Revised Health Impact Assessment Review Document for

**Vantage Data Center
Quincy, Washington**

**Air Quality Program
Olympia, Washington**

May 11, 2017

Figure 1. Residential parcels in the area where the average annual DEEP concentrations could exceed the ASIL

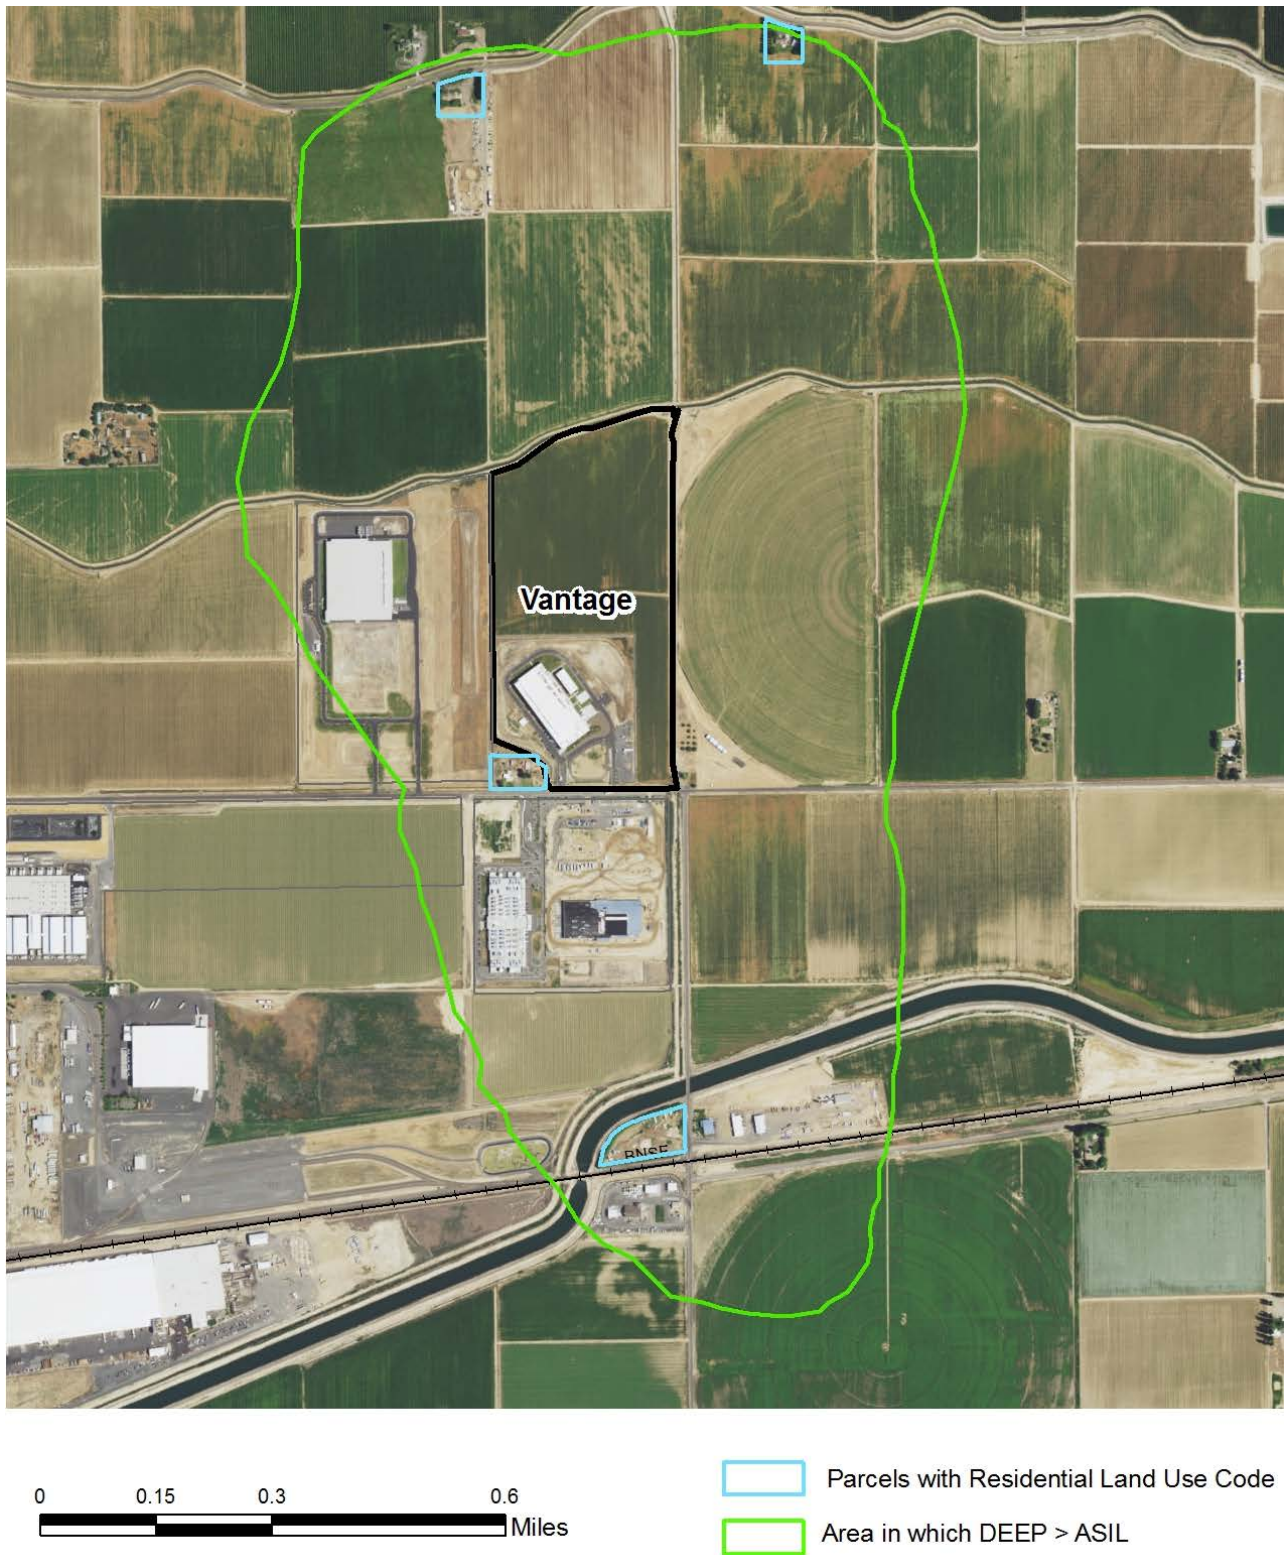
While Vantage Data Center is located in an industrially zoned area and surrounded largely by agricultural land uses, air dispersion modeling indicated that proposed DEEP emissions could result in concentrations in excess of the ASIL at roughly 4 parcels with residential land use codes (Figure 1) [Ecology, 2015; Grant County, 2015]. U.S. Census data show that approximately 12 people live in the area in which DEEP concentrations are estimated to exceed the ASIL (U.S. Census Bureau, 2010).³

Figure 2. Receptor locations evaluated in the HIA in relation to estimated average annual DEEP concentrations. Concentrations are reported as the number of times higher than the ASIL.

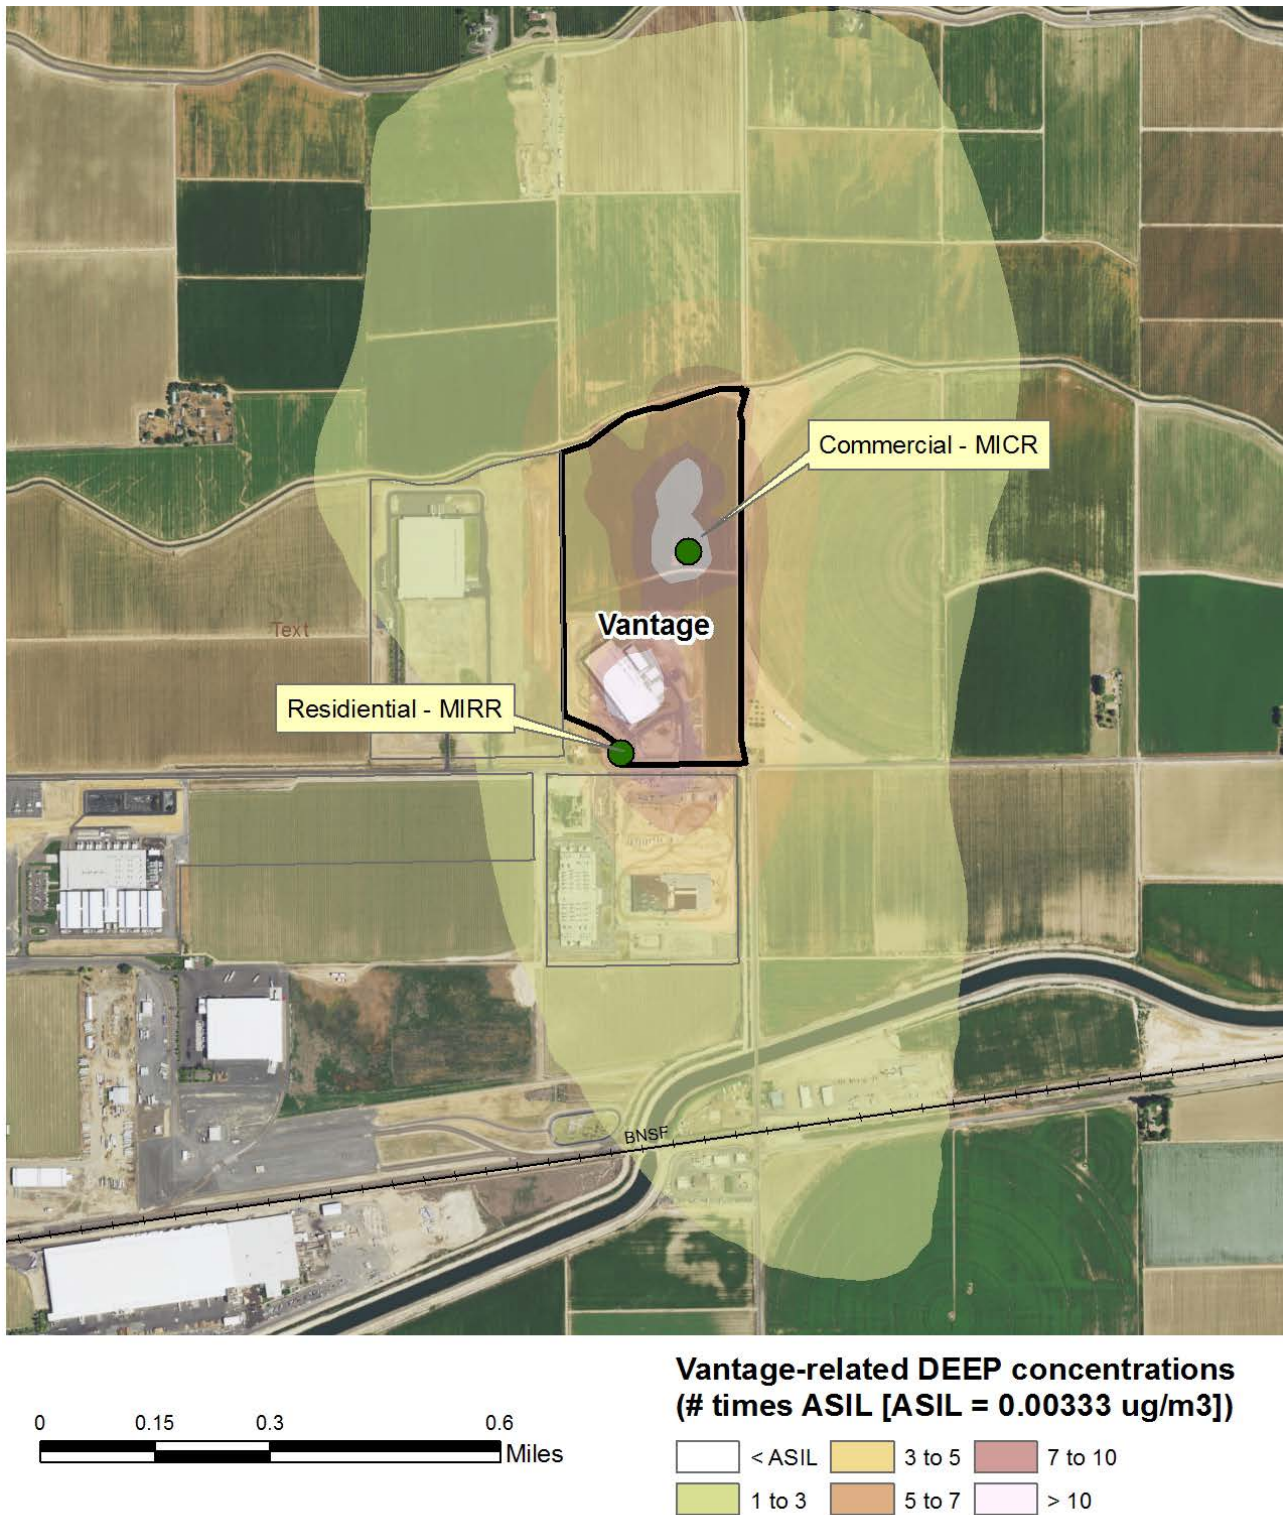
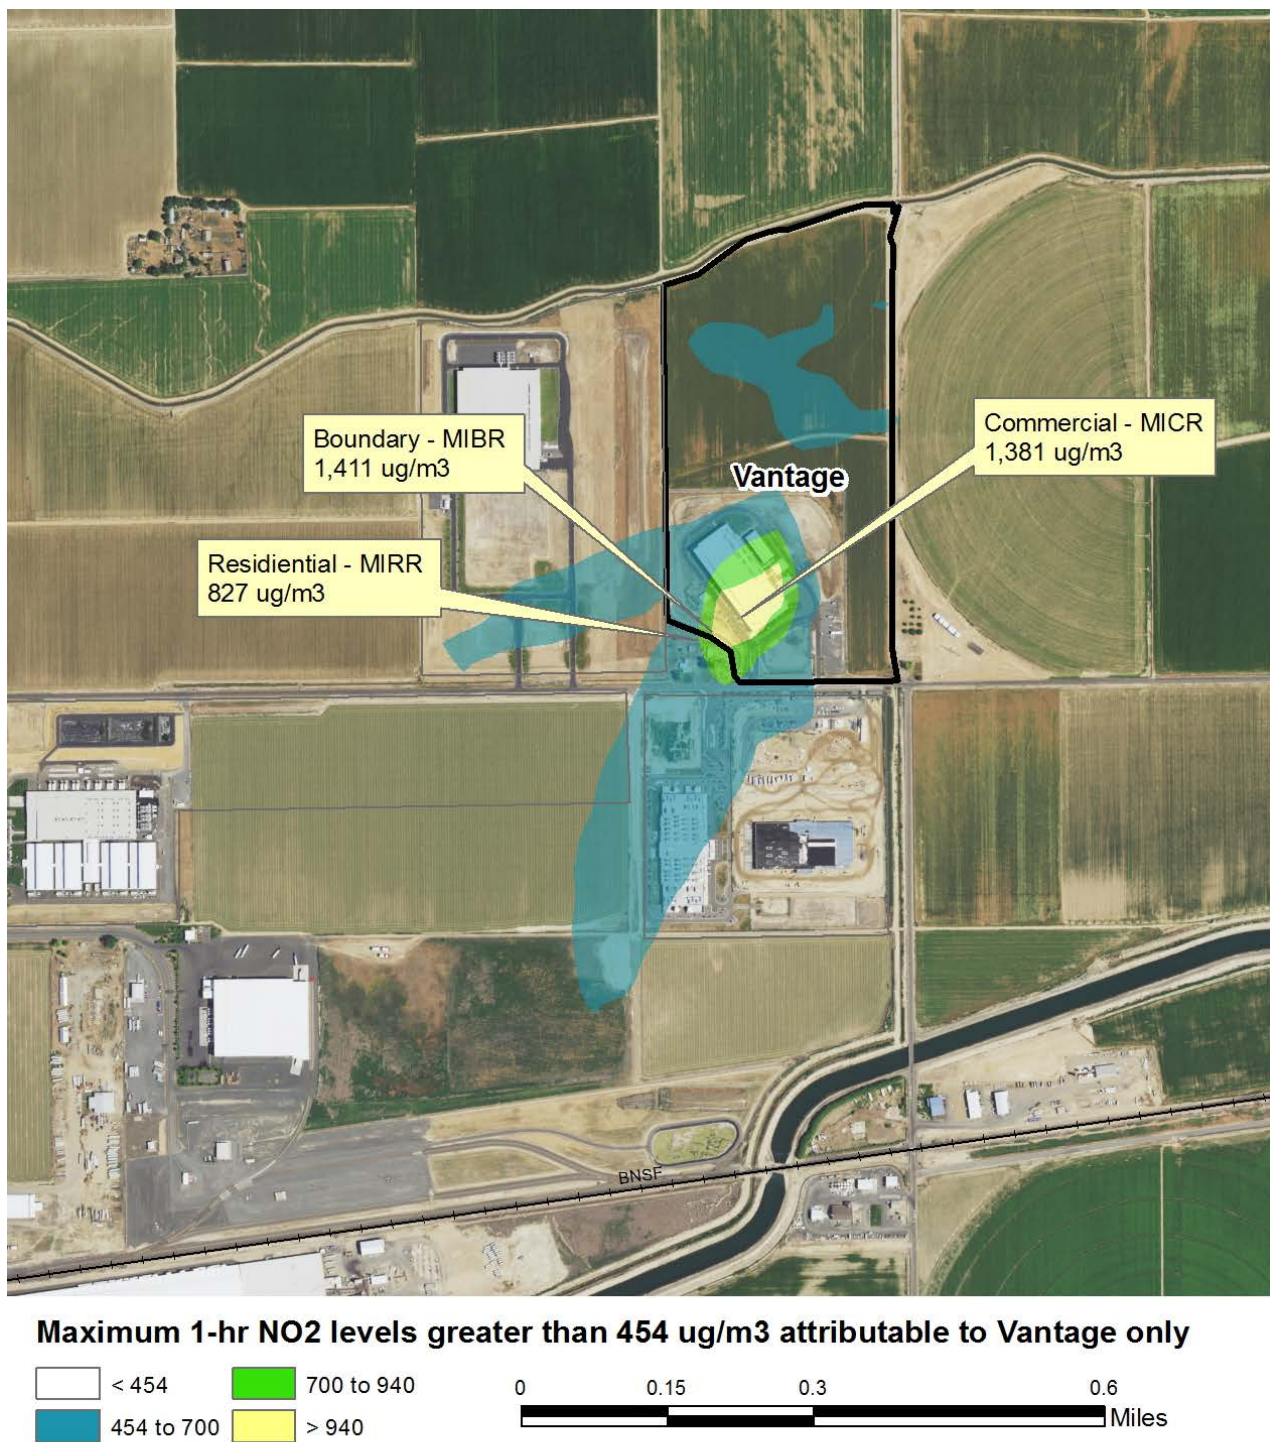
Ecology's review of the HIA found that Landau Associates identified appropriate receptors to capture the highest exposures for residential, commercial, and fence line receptors (Figures 2 and Figure 3). Landau Associates also identified other potential sensitive receptor areas such as students at Quincy High School. These receptors are located outside the area in which Vantage-specific TAP impacts exceed ASILs.

Figure 4. Cumulative DEEP concentrations (estimated by Landau Associates) in the Vantage Data Center vicinity. Concentrations are reported as the number of times higher than the ASIL.

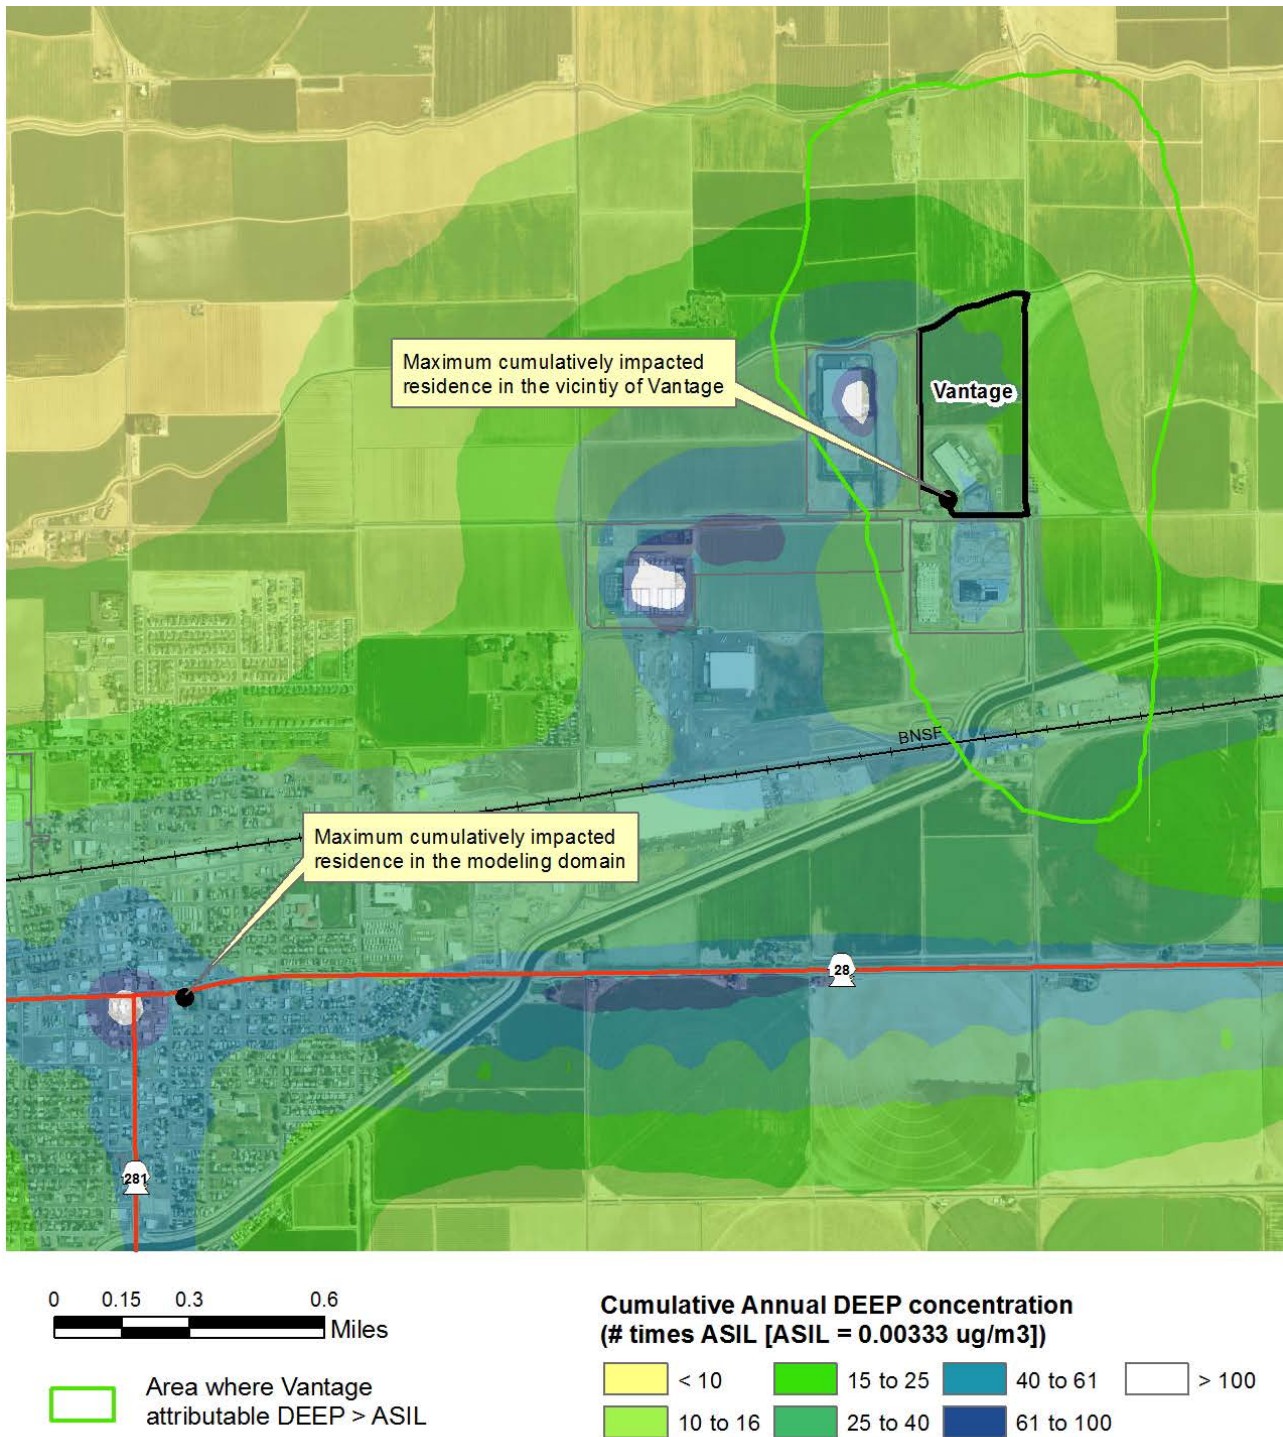
Landau Associates conducted a separate analysis of cumulative exposure to DEEP in Quincy. The cumulative risk of all known sources of DEEP emissions in the vicinity of Vantage Data Center (Table 3 and Figure 4) is highest for the residence adjacent to Vantage’s southwest property boundary. The cumulative DEEP risk at this home is about 39 per million.⁶ The majority (~79 percent) of estimated DEEP exposure at this location is attributable to allowable emissions from emergency engines at nearby data centers. Landau Associates also identified a home within the modeling domain approached 100 per million near the center of town. It is important to note that the tax parcel information defines this location with a land use code “53” (General Merchandise Retail), but street view photographs indicate that a residence may exist. Regardless, Vantage’s contribution to diesel PM at this location is insignificant.

Figure 5a. Estimated time interval between occurrences of NO₂ levels of concern at the MIBR depending on the number of hours of power outage experienced by Vantage and other east Quincy Data Centers assuming all permitted engines operate at outage loads.

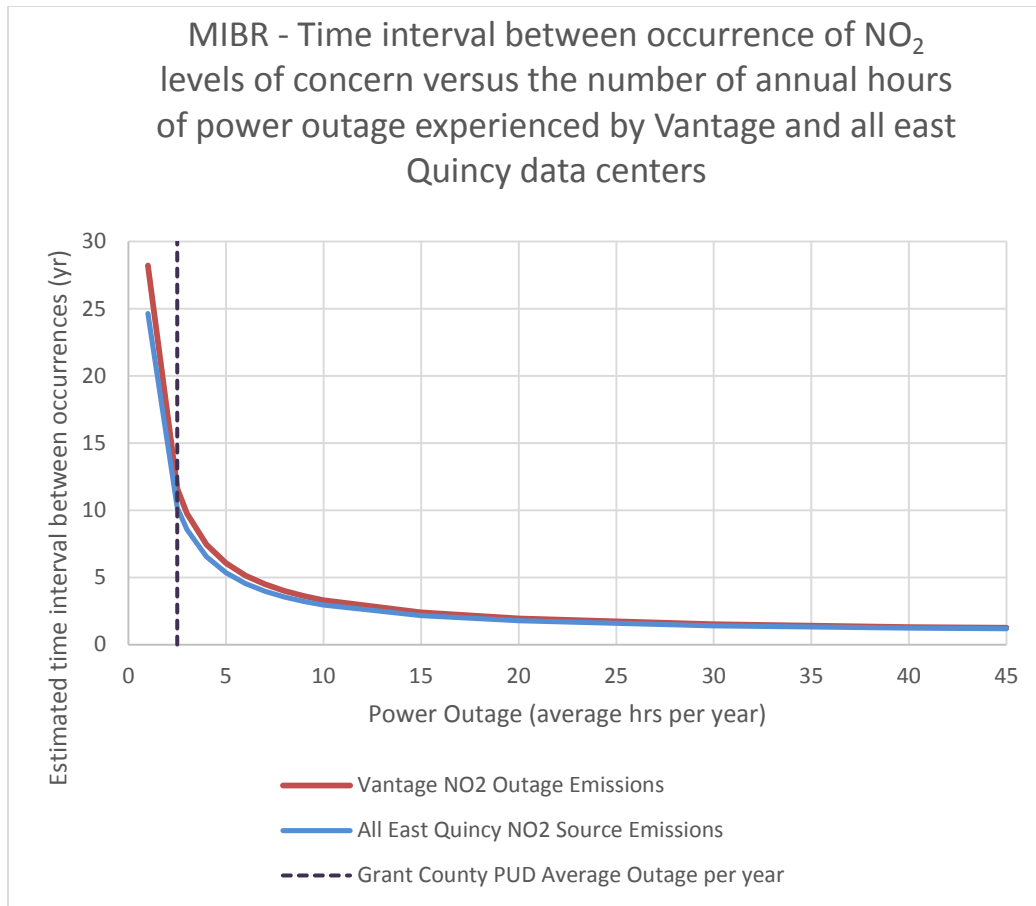
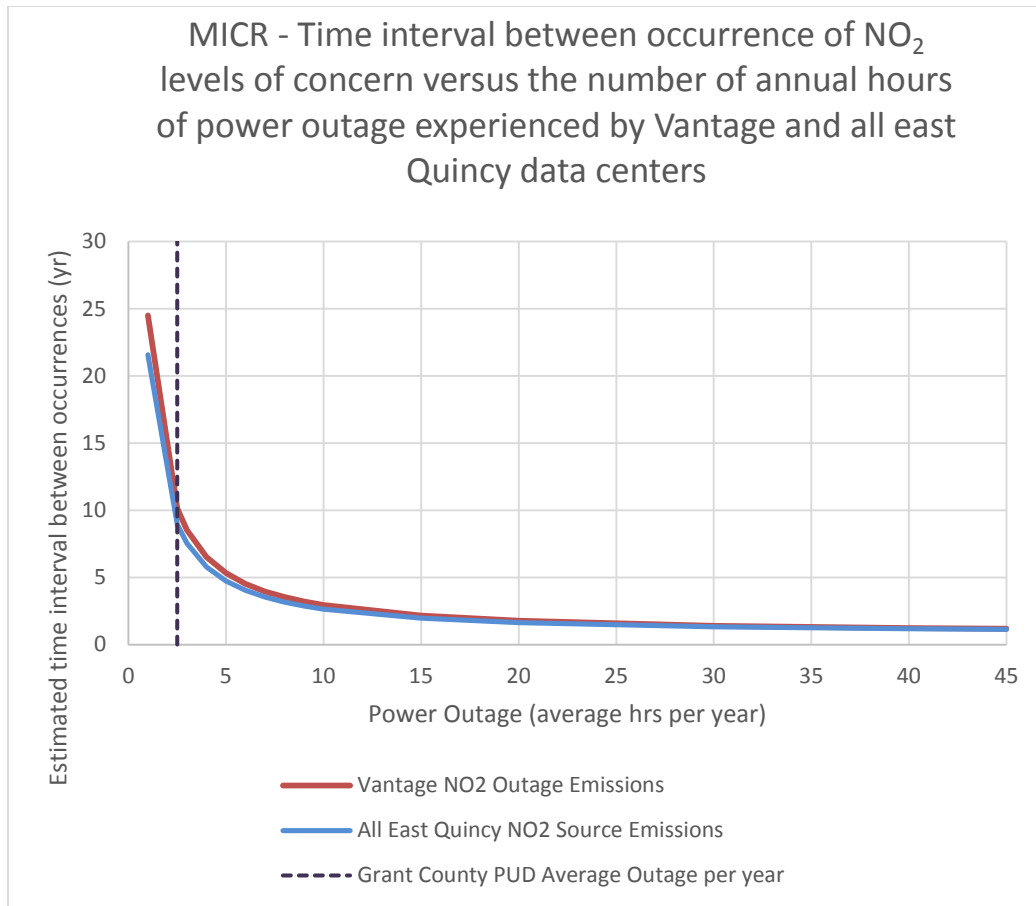
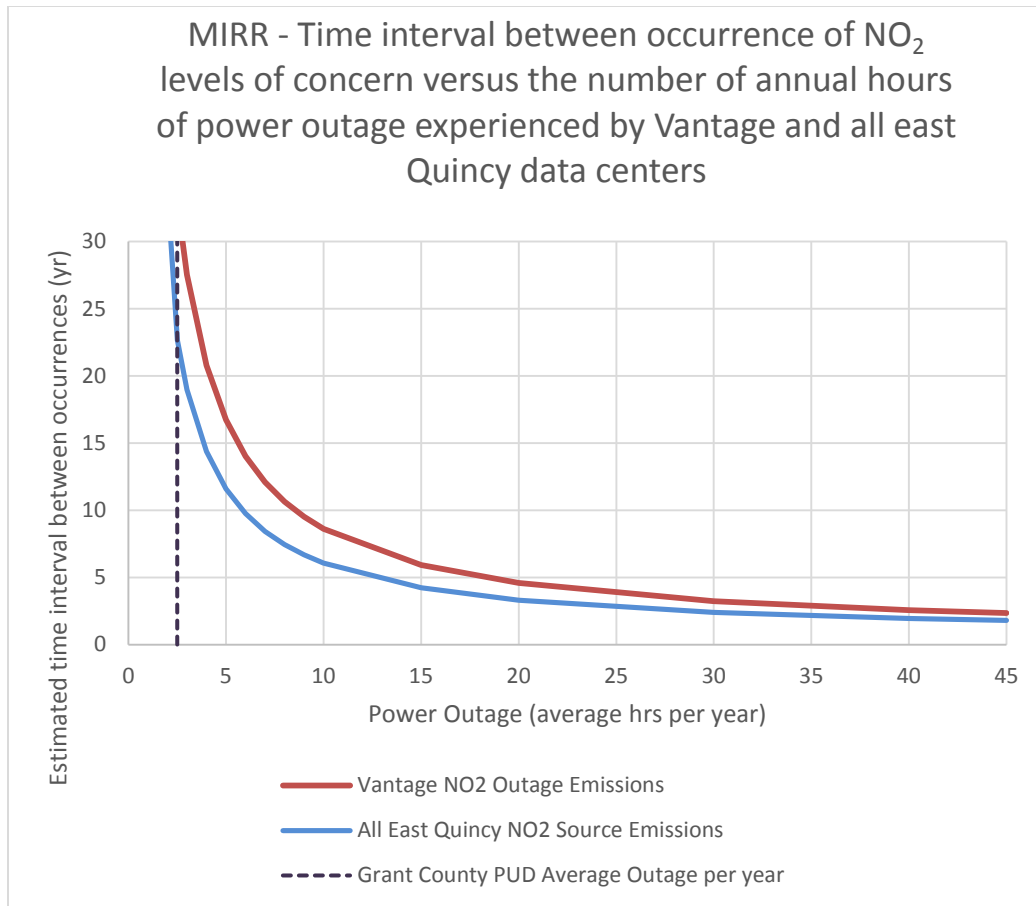
Figures 5a -5c shows the number of years between occurrences in which the NO₂ levels could exceed a level of concern at the MIBR, MICR, and MIRR assuming each east side data center operates each engine at outage load during one to 45 hours of simultaneous outage per year. Generally, the occurrences of elevated NO₂ levels will be infrequent if the frequency and duration of power outages remains low. Assuming 2.5 hours of simultaneous power outage per year, NO₂ levels could exceed a level of concern about once every 9, 10, and 23 years at the MICR, MIBR, and MIRR respectively.
